Alterations for:
MS. NOELI SANCHEZ
 6435 CORAL WAY
 MIAMI, FLORIDA 33155
 PHONE: (305) 663-7272

Date: 9-14-05
 Scale:
 Drawn:
 Job: 05058
 Sheet: **A-1**
 Of: Sheets

LANDSCAPE PLAN

MS. NOELI SANCHEZ

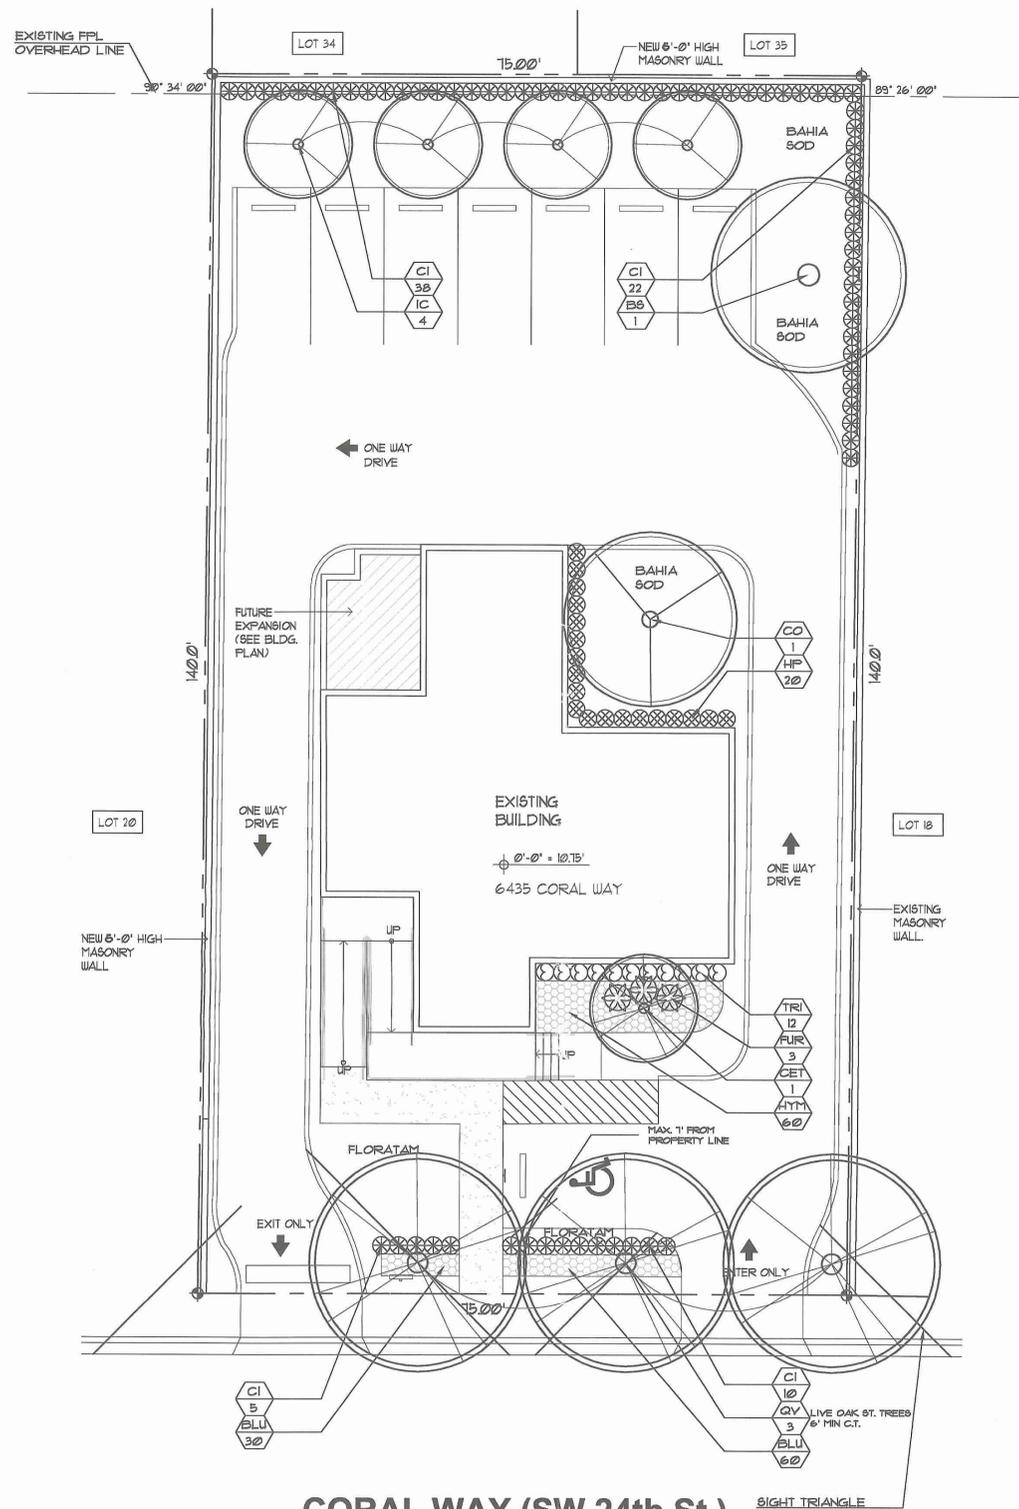
See pline landscape area attach showing 27.75% open space

900
 225
 380
 176
 135
 273
 288
 36
 133.6
 2258.6
 109.6
 2367.6 / 10,500 = 22.5% open space
